| Model: Stinger-C1 Paper Tray Unit / 1 Tray (PS400) | | Date: 15-Dec-99 | No.: MA861001 |

| Model: Stinger-C1 Paper Tray Unit/1Tray (PS400) | Date: 15-Dec-99 | No.: MA861002a |

| Modified Article: Change in Spring Guard | | Prepared by: K. Miura | |

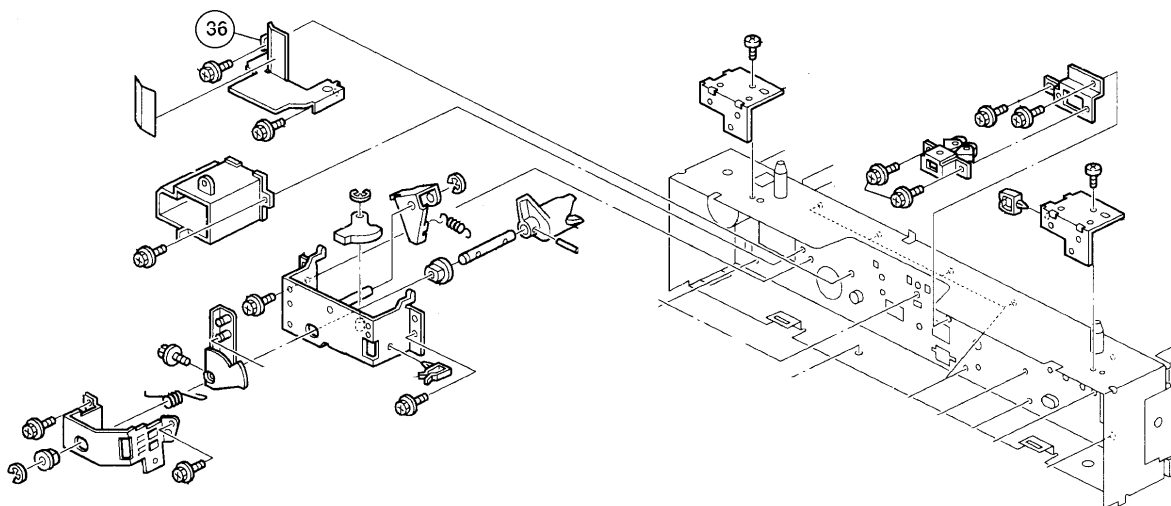
The shape of the spring guard has been modified to facilitate removal.

| Old part number | New part number | Description | Q'ty | Int | Page | Index | Note |
|-----------------|-----------------|--------------|------|------------|------|-------|------|
| A8601190 | A8611186 | Spring Guard | 1 | X/O | 9 | 36 | |

| Modified Article: Mylar added to plate springs | | Prepared by: K. Miura | |

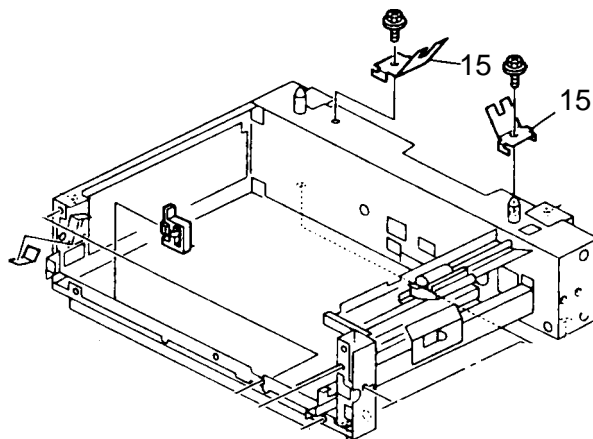
For increased safety, a mylar strip has been added to both plate springs located in between the paper feed unit and mainframe.

| Old part number | New part number | Description | Q'ty | Int | Page | Index | Note |
|-----------------|-----------------|--------------|------|-----|------|-------|------|
| H5194547 | A8601140 | Spring Plate | 2 | X/O | 3 | 15 | |

| Modified Article: Shape Modification of Paper Size Sensor Bracket | | Prepared by: K. Miura | |

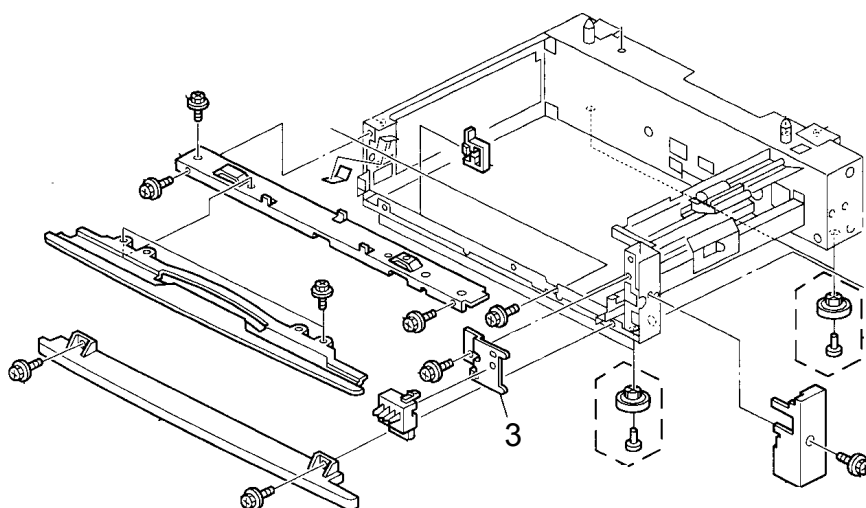
The shape of the paper size sensor bracket has been changed to ensure proper paper size detection.

| Old part number | New part number | Description | Q'ty | Int | Page | Index | Note |
|-----------------|-----------------|-----------------------------|------|-----|------|-------|------|
| A8611121 | A8611123 | Bracket – Paper Size Sensor | 1 | X/X | 3 | 3 | |

| Modified Article: Bottom plate pad modification - OHP transparency feed | | | Prepared by: K. Miura |

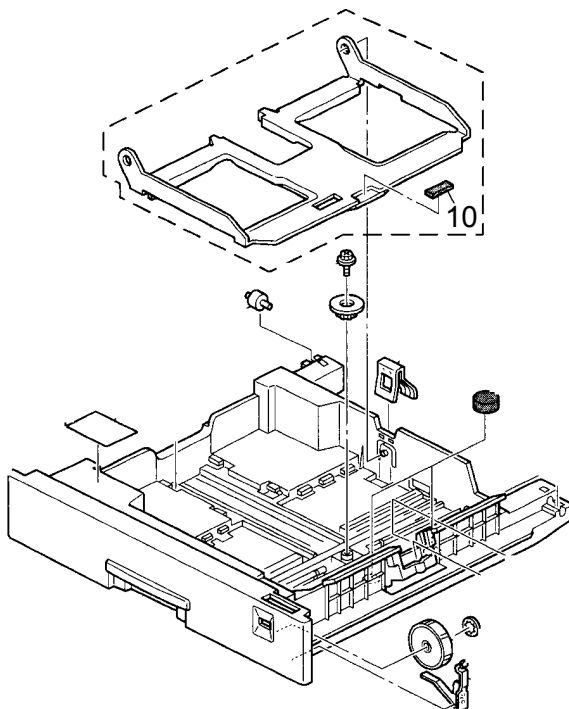
In order to ensure proper feed of OHP transparencies, a material with a lower rubber content is now used for the bottom plate pad. This material has a lower coefficient of friction and is effective against the following symptoms of OHP feed:

- Last sheet non-feed (jam display)
- Skewing
- Noise

| Old part number | New part number | Description | Q'ty | Int | Page | Index | Note |
|-----------------|-----------------|------------------|------|-----|------|-------|------|
| G0292608 | 52152713 | Bottom Plate Pad | 1 | X/O | 5 | 10 | |

| Modified Article: Base Pad | | Prepared by: K. Miura | |

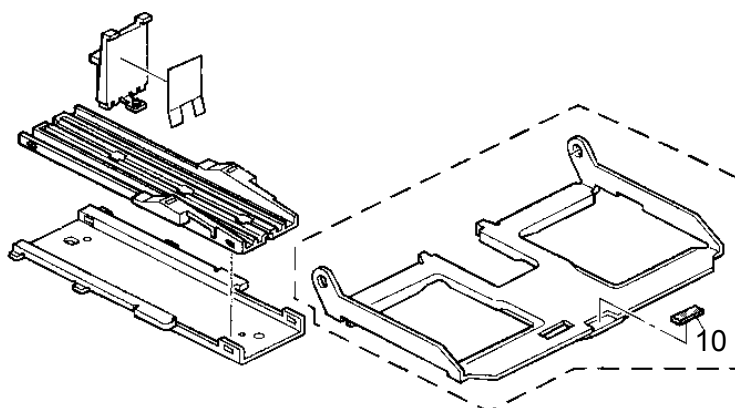
Due to the measurement specifications of the bottom plate pad, it is possible for the pad to be wider than the opening in the bottom plate. To ensure that the pad will fit in the opening, the base pad for the Russian will be used.

| Old part number | New part number | Description | Q'ty | Int | Page | Index | Note |
|-----------------|-----------------|------------------|------|-----|------|-------|------|
| 52152713 | | Bottom Plate Pad | 1 | O/O | 5 | 10 | |
| | A2672917 | Base Pad | 1 | O/O | 5 | 10 | |

| Modified Article: Spring Plate | | Prepared by: K. Miura | |

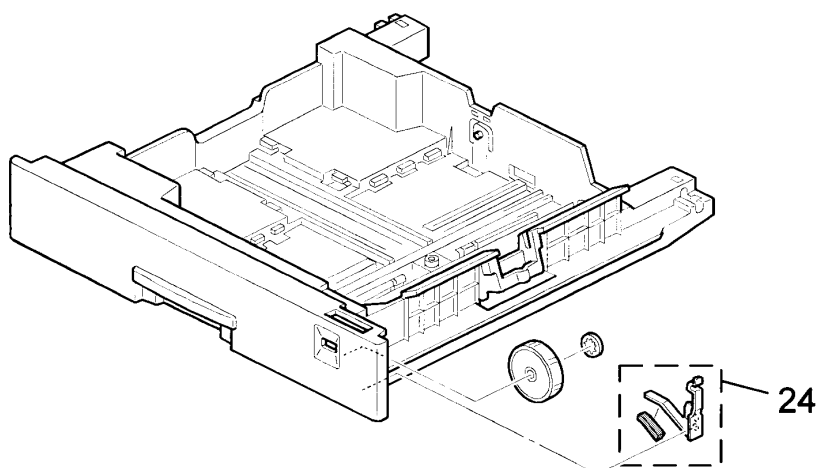
The edge of the spring pate for the paper size dial is relatively sharp. To ensure proper safety, a sponge has been added to the plate.

| Old part number | New part number | Description | Q'ty | Int | Page | Index | Note |
|-----------------|-----------------|-----------------------|------|-----|------|-------|------|
| A2672868 | A2672870 | Sponge – Spring Plate | 1 | X/O | 5 | 24 | |

| Modified Article: Spring Plate | | Prepared by: K. Miura | |

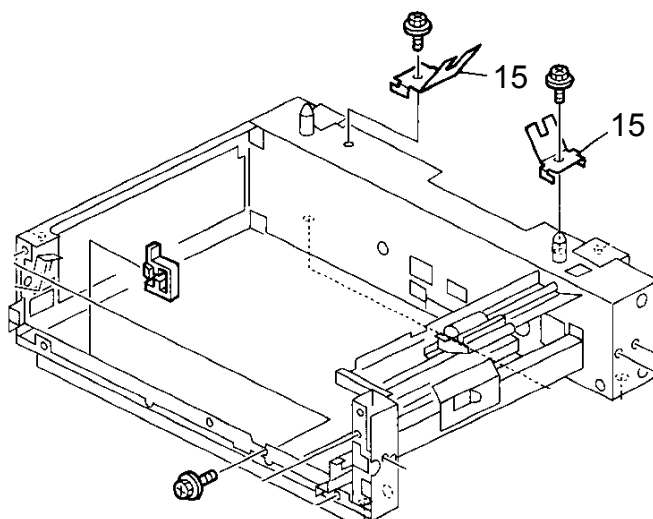
Although previously, a mylar was added to the spring plate to protect it from damage (MB #MA861003), the shape of the spring plate itself has now been modified to perform the same function.

| Old part number | New part number | Description | Q'ty | Int | Page | Index | Note |
|-----------------|-----------------|--------------|------|-----|------|-------|------|
| A8601140 | B3841146 | Spring Plate | 2 | X/O | 3 | 15 | |

| Modified Article: Bracket Material Change | | Prepared by: K. Miura | |

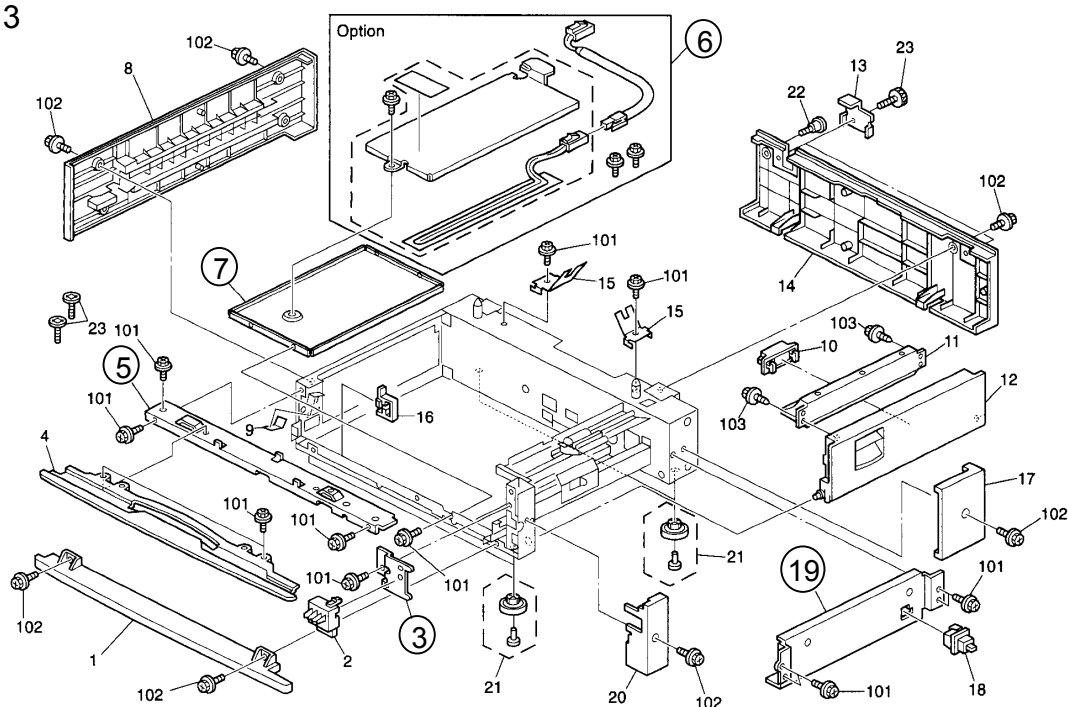
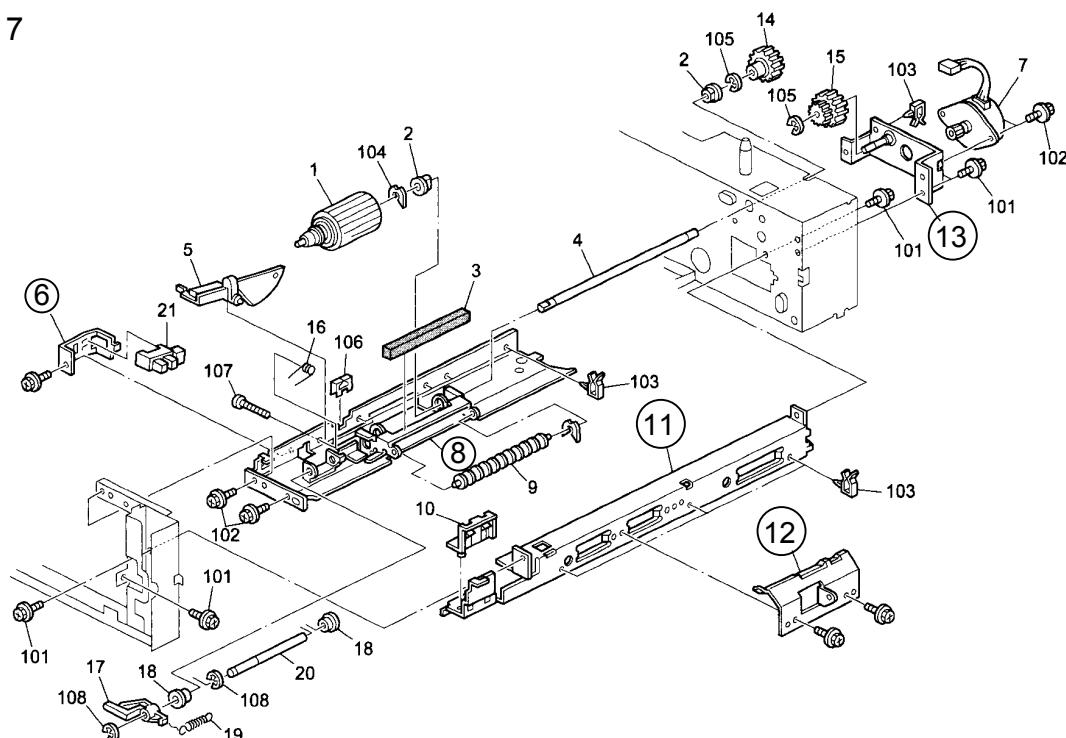
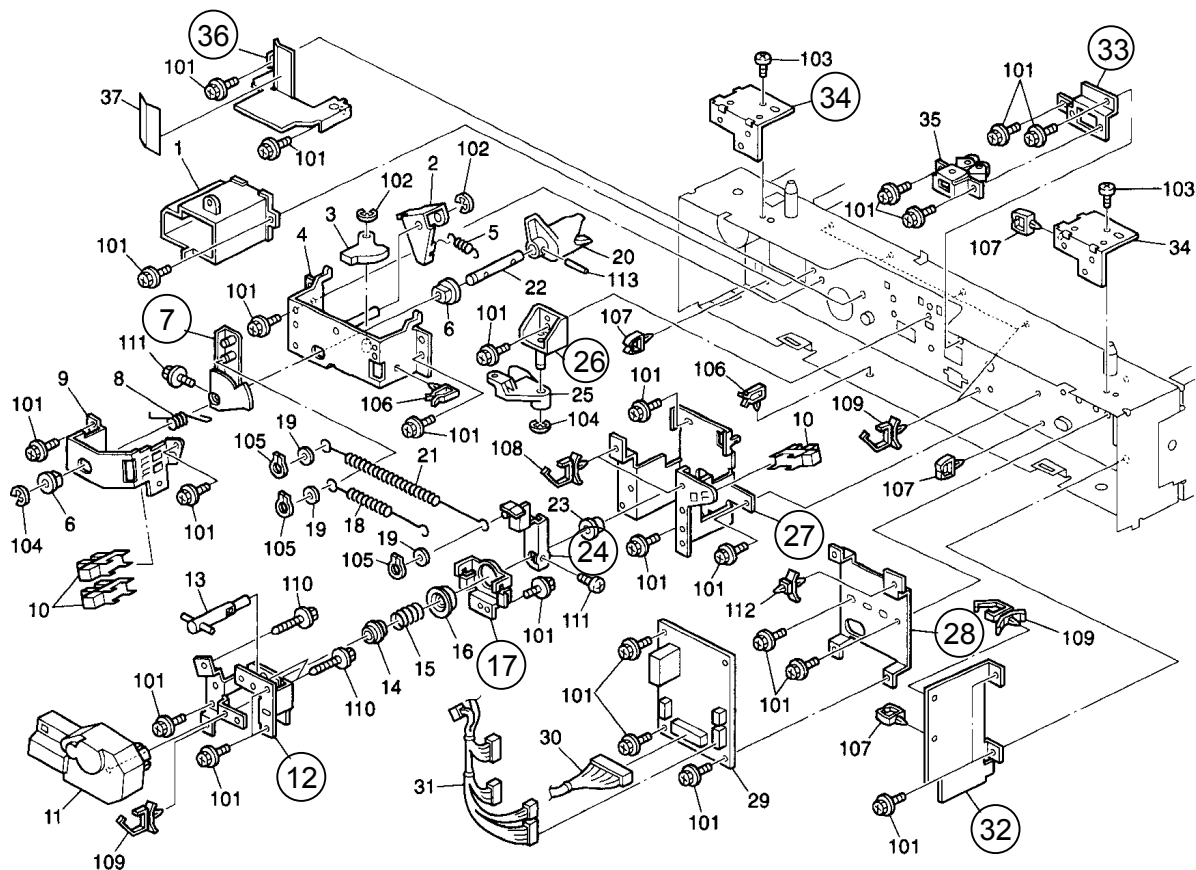
A material change has been applied to the following brackets and bracket portions of the following components.

| Old part number | New part number | Description | Q'ty | Int | Page | Index | Note |
|-----------------|-----------------|--------------------------------|------|-----|------|-------|------|
| A8611106 | B3851106 | Upper Front Stay | 1 | O/O | 3 | 5 | |
| A8611108 | B3851108 | Right Stay | 1 | O/O | 3 | 19 | |
| A8611123 | B3851123 | Bracket - Paper Size Switch | 1 | O/O | 3 | 3 | |
| A8611136 | B3851136 | Tray Heater Bracket | 1 | O/O | 3 | 7 | |
| A8616300 | B3856300 | Tray Heater | 1 | O/O | 3 | 6 | |
| A2672805 | B0242805 | Bracket - Paper End Sensor | 2 | O/O | 7 | 6 | |
| A2672842 | B0242842 | Bracket - Friction Pad Guide | 2 | O/O | 7 | 12 | |
| A8601090 | B3841090 | Right Guide Rail | 2 | O/O | 7 | 11 | |
| A8602555 | B3842555 | Feed Roller Bracket | 2 | O/O | 7 | 8 | |
| A8612825 | B3852825 | Feed Motor Bracket | 1 | O/O | 7 | 13 | |
| A2672781 | B0242781 | Pressure Lever Bracket | 2 | O/O | 9 | 26 | |
| A2672908 | B0242908 | Tray Holder Bracket | 2 | O/O | 9 | 33 | |
| A8602726 | B3842726 | Lift Motor Bracket | 2 | O/O | 9 | 12 | |
| A8602728 | B3842728 | Spring Holder Bracket | 2 | O/O | 9 | 17 | |
| A8602893 | B3842893 | Actuator - Paper Height Sensor | 2 | O/O | 9 | 7 | |
| A8602895 | B3842895 | Lower Lever - Lift Motor | 1 | O/O | 9 | 24 | |
| A8611125 | B3851125 | Rear Cover Bracket | 2 | O/O | 9 | 34 | |
| A8611129 | B3851129 | Interface Bracket Guard | 1 | O/O | 9 | 32 | |
| A8611140 | B3851140 | Interface Board Bracket | 1 | O/O | 9 | 28 | |
| A8611186 | B3851186 | Spring Guard | 1 | O/O | 9 | 36 | |
| A8612566 | B3852566 | Main Bracket - Lift Motor | 1 | O/O | 9 | 27 | |

Modified Article: Parts Catalog Correction

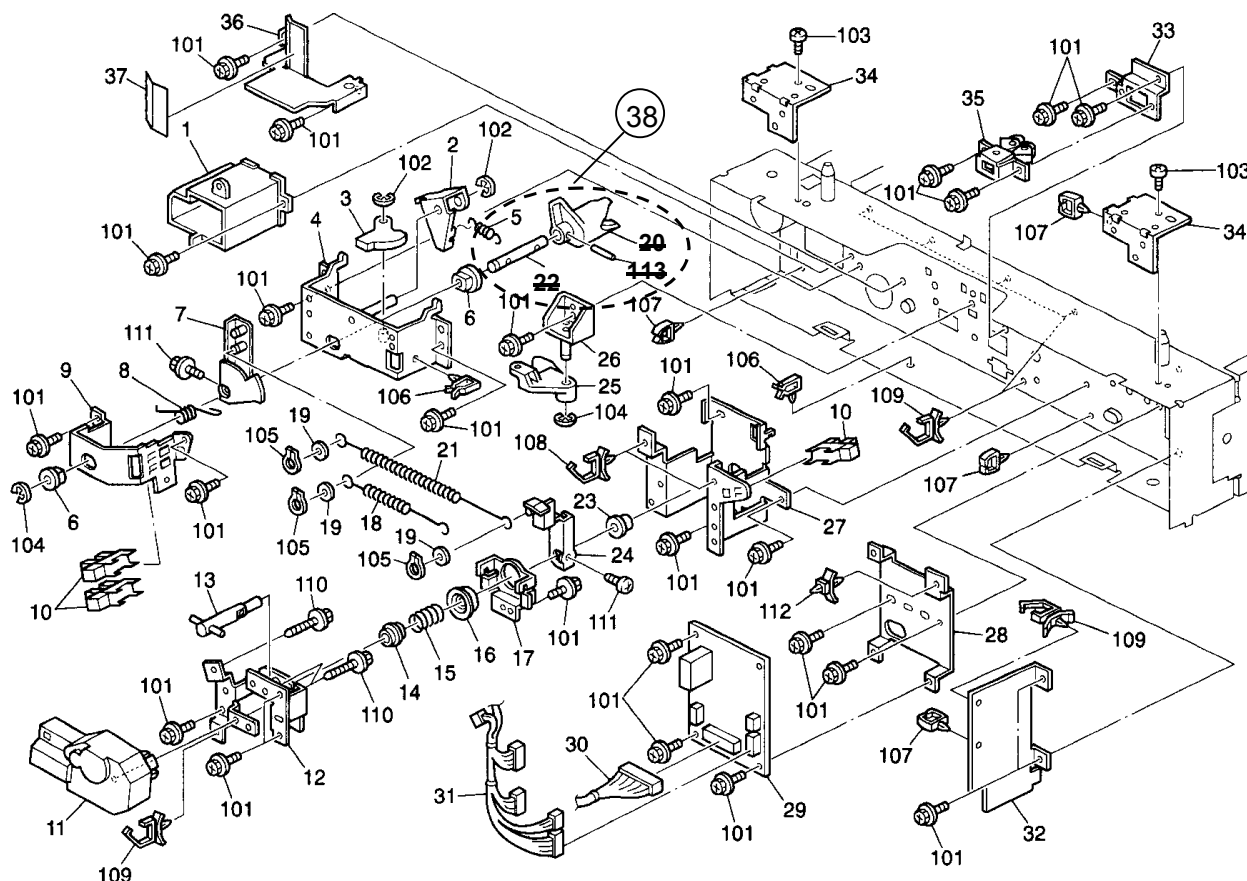
Please correct your Part Catalog as follows:

| Old part number | New part number | Description | Q'ty | Page | Index | Note |
|-----------------|-----------------|---------------------|------|------|-------|------|
| A2672761 | | Joint – Shaft | 1 | 9 | 20 | |
| A2672762 | | Shaft | 1 | 9 | 22 | |
| 06230140E | | Spring Pin – 3x14mm | 1 | 9 | 113 | |
| | A2672756 | Joint - Shaft | 1 | 9 | 38 | |

| Modified Article: Paper Feed Unit | | Prepared by: K. Miura | |

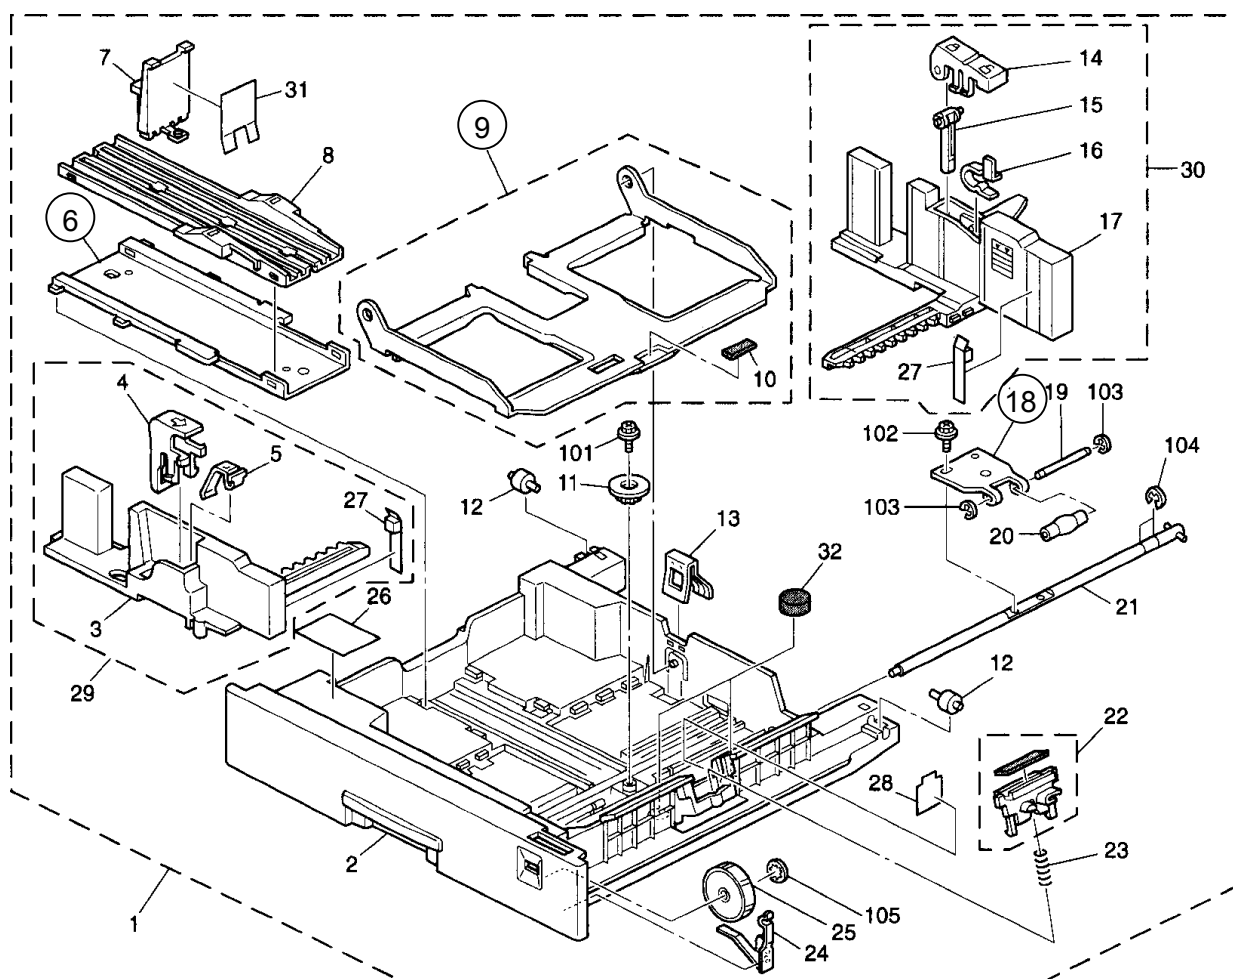
A material change has been applied to the following brackets and bracket portions of the following components.

| Old part number | New part number | Description | Q'ty | Int | Page | Index | Note |
|-----------------|-----------------|------------------|------|-----|------|-------|------|
| A2672874 | B0242874 | Base Slider | 1 | O/O | 5 | 6 | |
| A2672861 | B0242861 | Bottom Plate | 1 | O/O | 5 | 9 | |
| A2672856 | B0242856 | Bracket - Rising | 1 | O/O | 5 | 18 | |

| Modified Article: Rear Cover Screw | | Prepared by: K.Miura | |

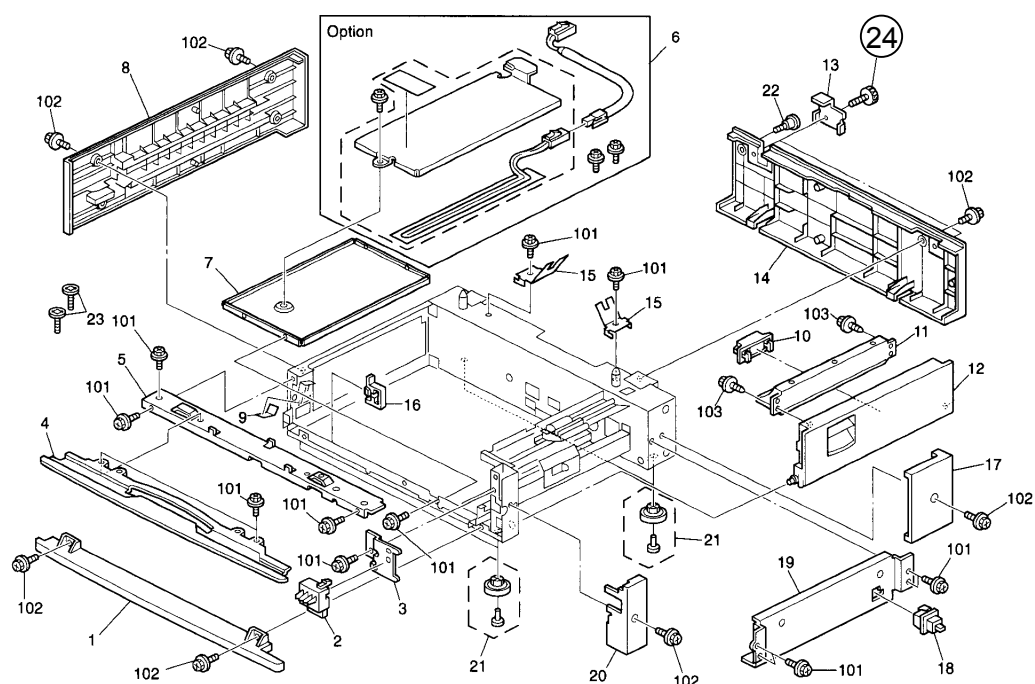
To maximize the Rear Cover's resistance to warping under high temperatures (over 60°C), the M4x10 Flat Knob Screw for the cover has been changed to an M4x11 screw in the two areas shown below (index 24).

Note: Since the M4x10 screw (index 23) is still being used in the remaining 2 areas, its service parts quantity has been changed from 4 to 2 with no P/N change.

| Old part number | New part number | Description | Q'ty | Int | Page | Index | Note |
|-----------------|-----------------|-------------------------|------|-----|------|-------|------|
| AA143508 | AA143508 | Flat Knob Screw – M4x10 | 4-2 | | 3 | 23 | |
| | AA143775 | Screw: M4x11 | 2 | X/O | 3 | 24 | |
